Project Name: Lot 31/31A Bethesda, Site Plan Amendment, No. 82007018C

Description

Completed: 3.20.2017

Detail, Certified Site Plan Sheet, 82007018A

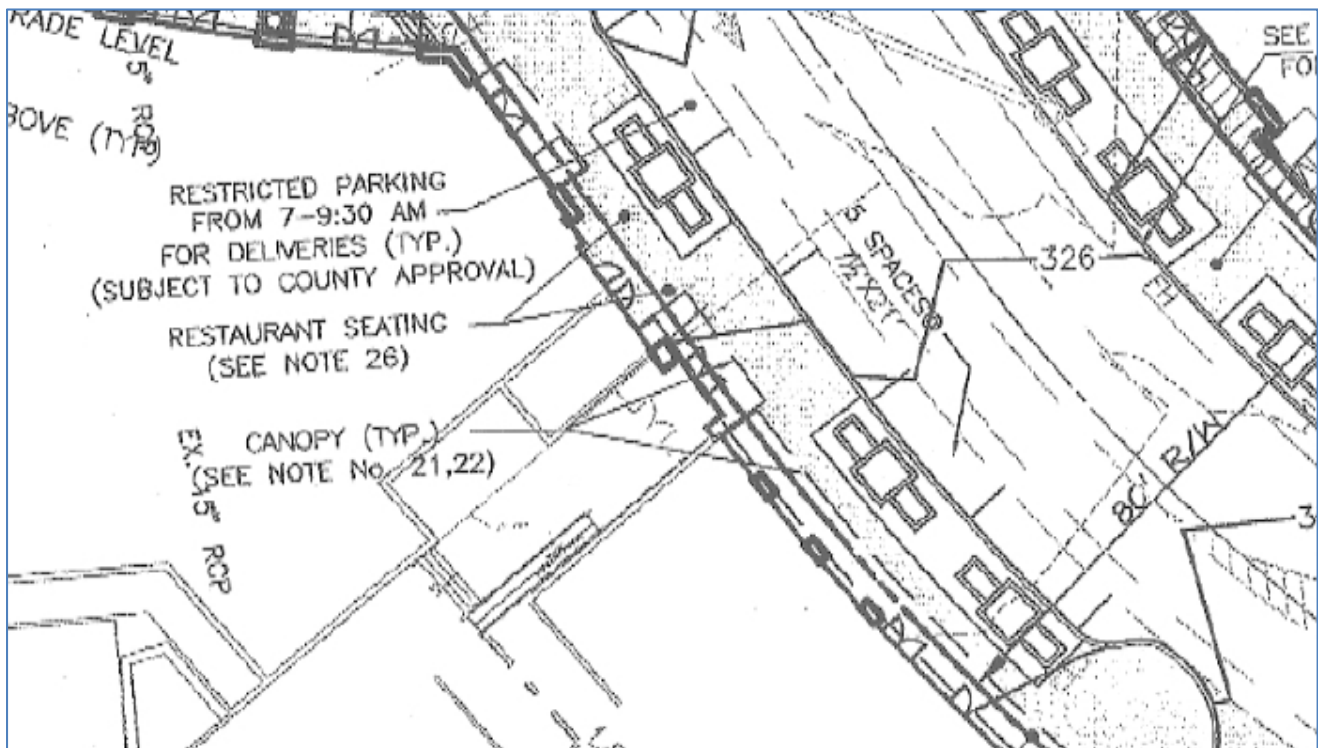
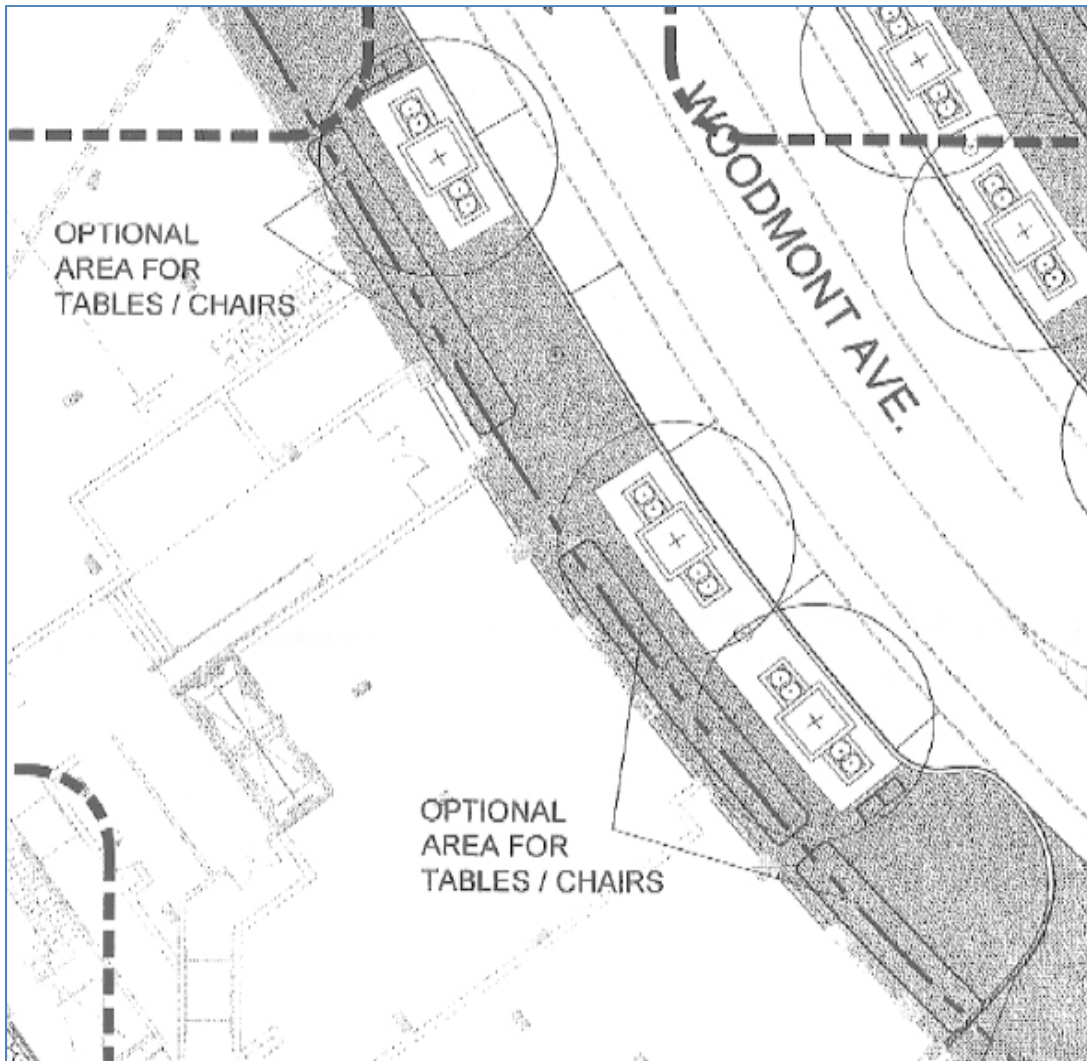
The Certified Site Plan drawings inconsistently show the area dedicated to outdoor seating at the Silver restaurant. The site plan sheet identifies the area between the tree pits and the building face as “Restaurant Seating (See Note 26)”. The Landscape Plan shows “Optional Area for Tables/Chairs” next to the building face.

Detail, Certified Site Plan Streetscape Detail, 82007018A

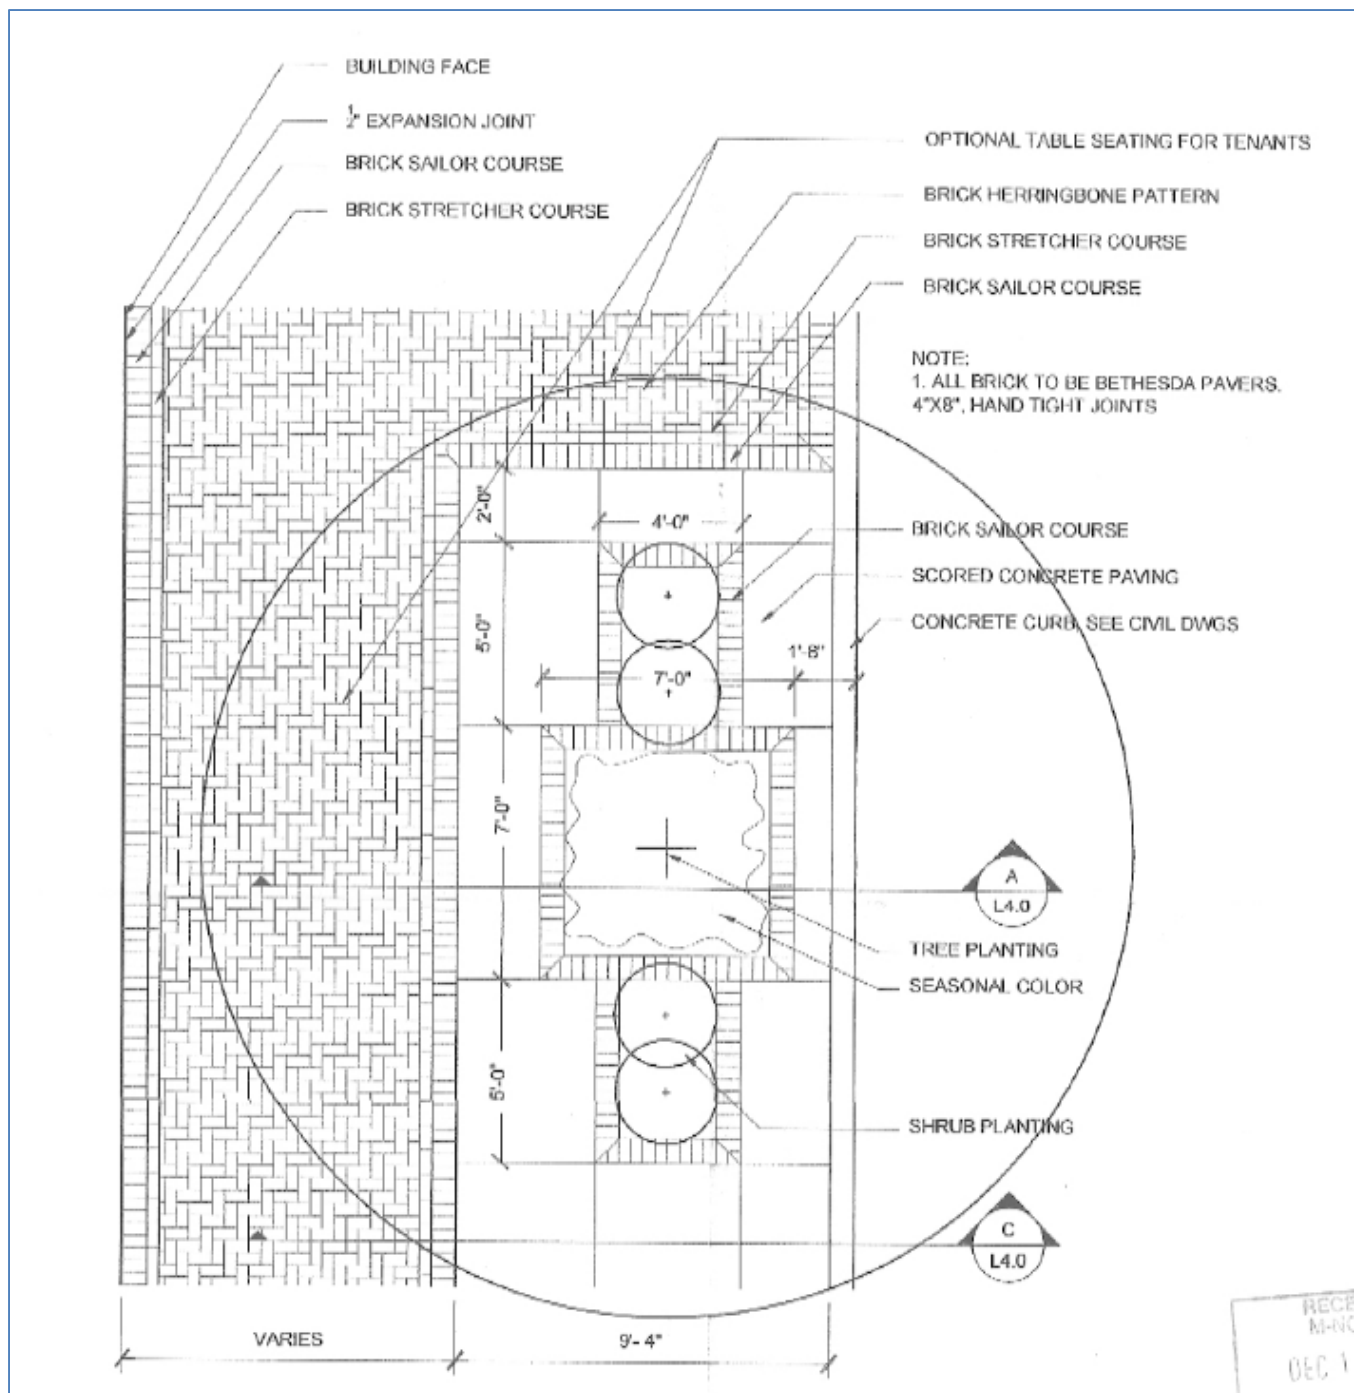
The Certified Site Plan also includes a streetscape detail that covers the sidewalk, illustrated below. This detail indicates that the depth of the tree-pit area, as differentiated from the brickwork area, is 9'-4" inside the curb, and that "Optional Table Seating for Tenants" could be located in the bricked sidewalk area between the tree-pit treatment as well as between that treatment and the building face. Given that the sidewalk in front of the Silver is about 17-18' wide, depending on where you measure, this detail would suggest that table seating would perforce be limited to the area between the tree pits to be consistent with Note 26.

Initial Proposed Woodmont Avenue Seating Layout, Silver

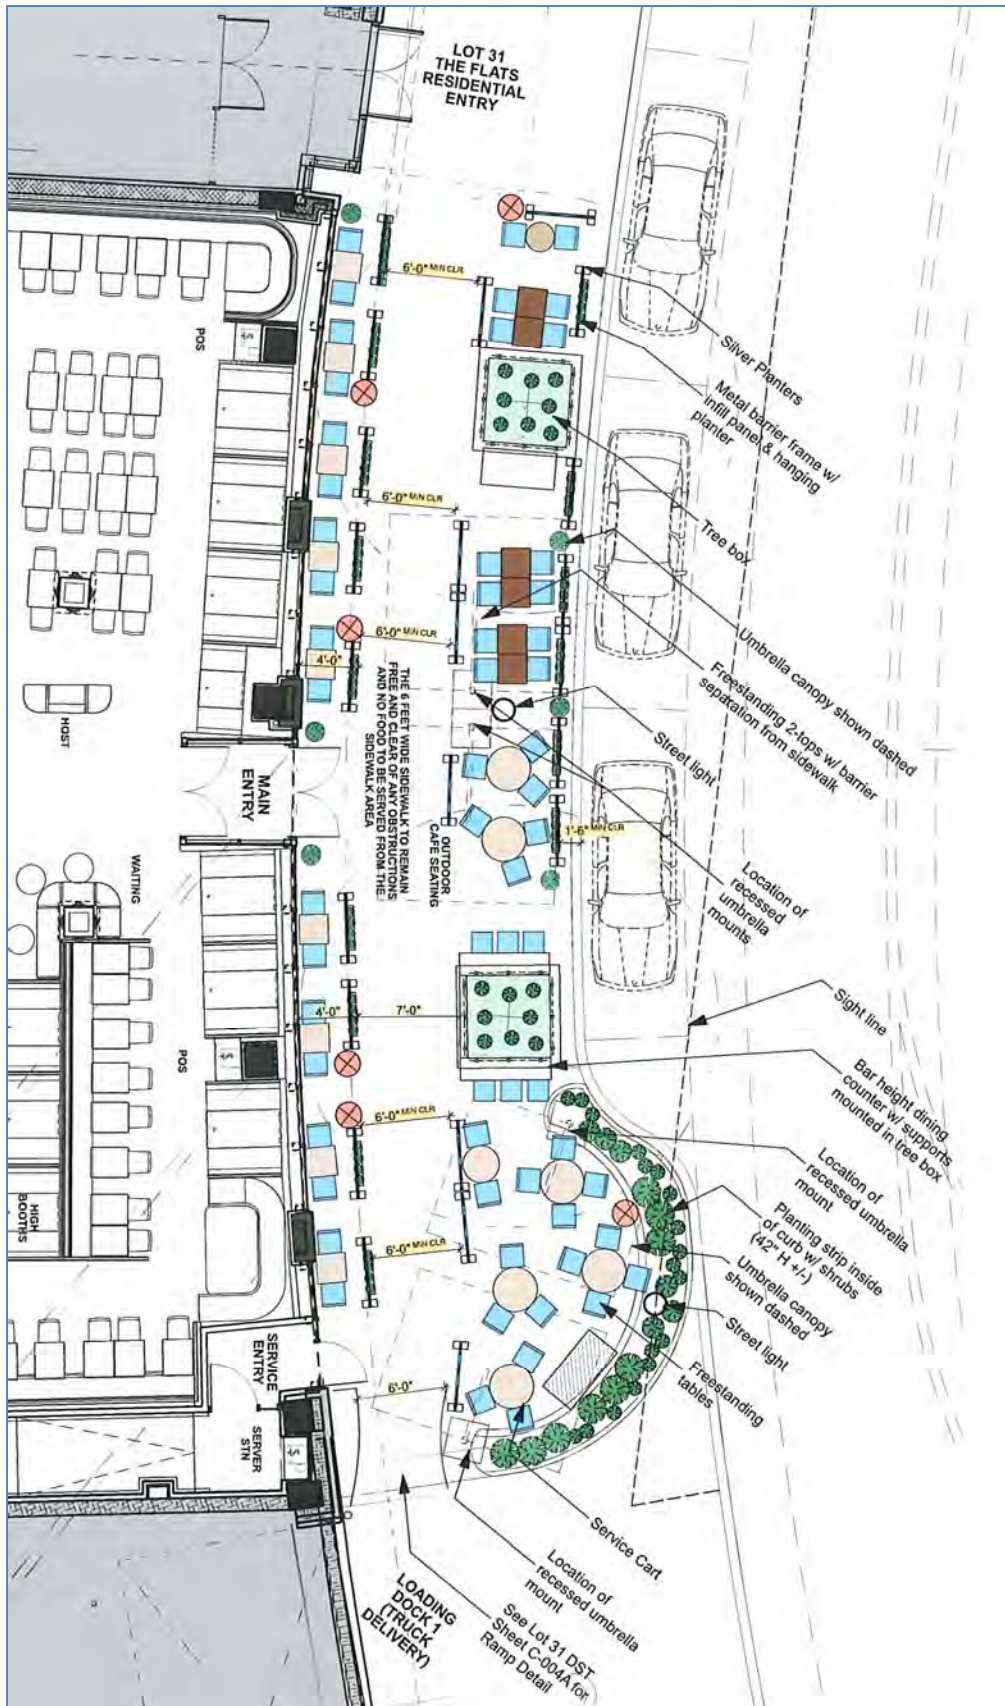
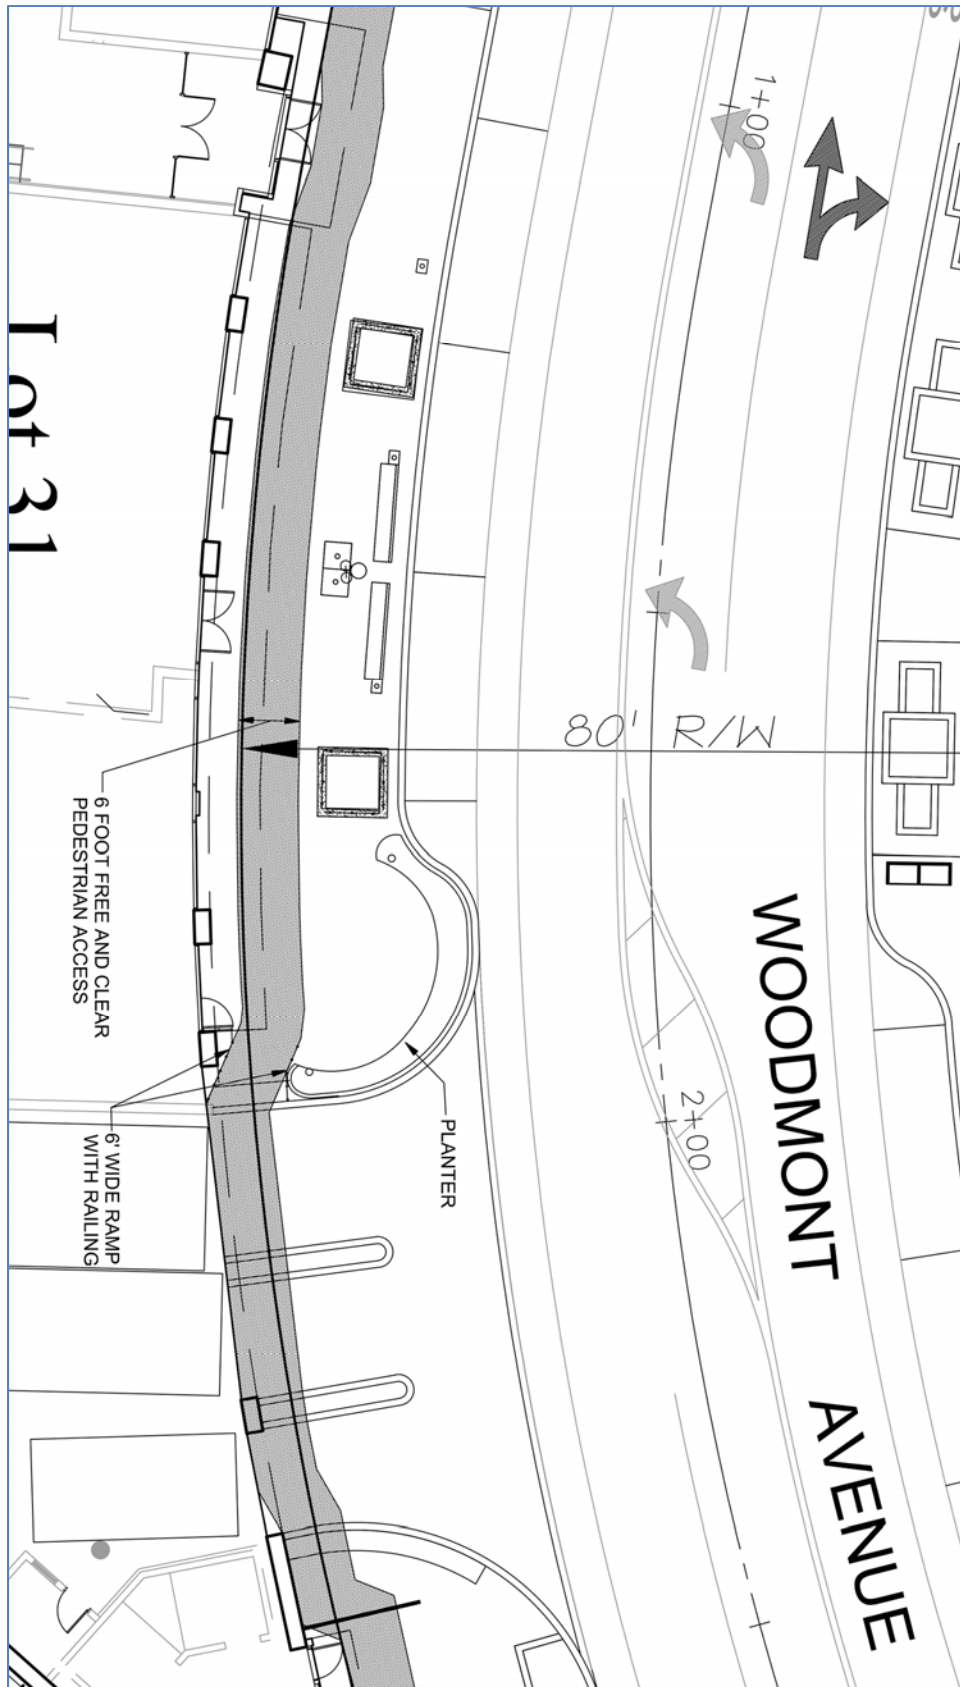
Instead of having a clear pedestrian area extending out approximately 10' from the face of the building, with seating between the pedestrian area and the curb, the Applicant initially proposed:

- 4' table seating area next to the building,
- 6' wide pedestrian area,
- 6-7' of table seating in the area between the street trees, and
- 1.5' clear area at the curb to accommodate car door swings.

The diagram on the next page further notes that "The 6 feet wide sidewalk to remain free and clear of any obstructions and no food to be served from the sidewalk area." The Applicant installed the alternative layout as a demonstration, shown below.

As discussed below, Staff determined that a clear pedestrian path of six feet, with service on both sides, was too narrow to properly balance the public needs of reasonably unimpeded pedestrian movement and the private needs of servicing Silver’s outdoor seating. After discussions with Staff, the Applicant submitted an updated design, illustrated on the next page.

Bethesda Streetscape Standard

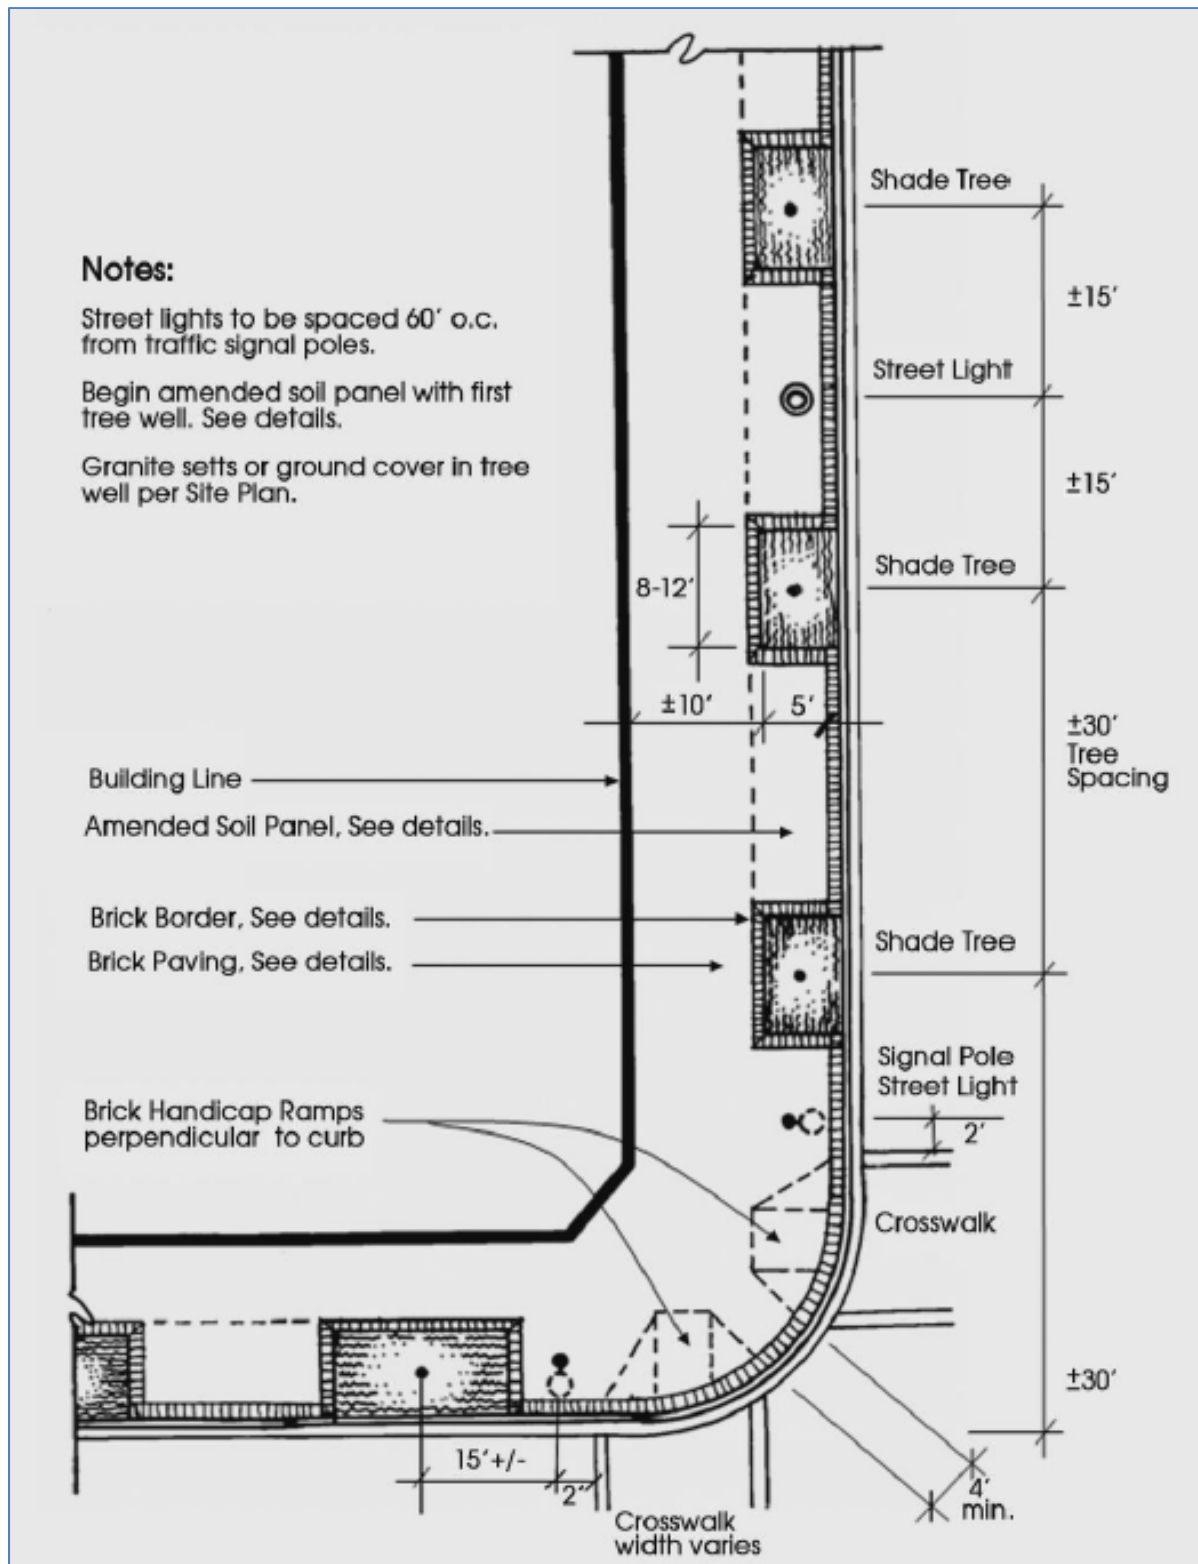
The *Bethesda Streetscape Plan Standards* (Streetscape Standards) calls out the minimum sidewalk width, between the building face and the tree pit, as 10'+/-, as shown below.

Woodmont Avenue looking north, Bethesda Row

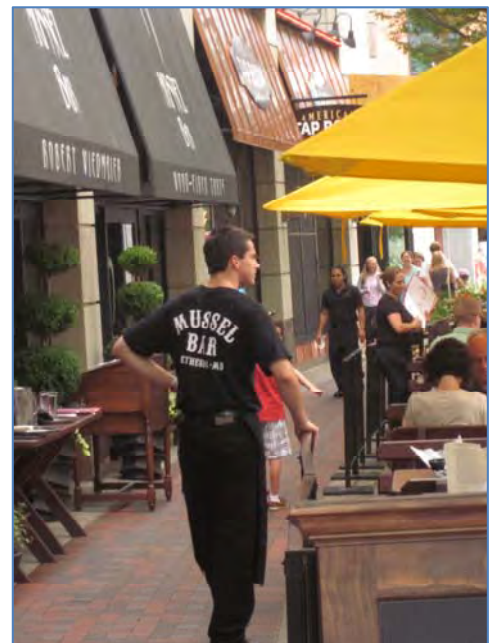
Pinch-points created by dining chairs, partitions, and other elements will create opportunities for further conflict, as illustrated in the photo (with apologies to the nameless server).
